Process Sheet

DART AEROSPACE LTD HAWKESBURY, ONTARIO, CANADA	
DRAWING NO. D3492	REV. C SHEET 1 OF 2
TITLE PLUG	SCALE 2:1
COPYRIGHT © 2007 BY DART AEROSPACE LTD THIS DOCUMENT IS PRIVATE AND CONFIDENTIAL AND IS SUPPLIED ON THE EXPRESS CONDITION THAT IT IS NOT TO BE USED FOR ANY PURPOSE OR COPIED OR COMMUNICATED TO ANY OTHER PERSON WITHOUT WRITTEN PERMISSION FROM DART AEROSPACE LTD.

DRAWING NO. D3492	TITLE PLUG	REV. C	DART AEROSPACE LTD ENGINEERING ORDER		D.E.O. NO. D3492-C-1	SHEET NO. SHEET 1 OF 1	SCALE NTS
DRAWN AJS	CHECKED	MFG. APPR.	APPROVED		DE APPR.		
DATE 08.11.05	DATE 08.11.05	DATE 08.11.05	DATE 08/11/05		DATE 08/11/05

SHEET 2 MODIFY -13 PLUG AS SHOWN:

D3492-XX PLUG MACHINING DETAILS

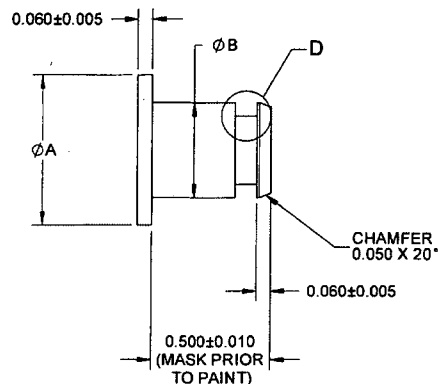
WAS:

P/N	A	B	C	MATERIAL SPEC
D3492-13	0.750	0.520	0.045	M6061T6R0.750

IS:

P/N	A	B	C	MATERIAL SPEC
D3492-13	0.750	0.510	0.045	M6061T6R0.750
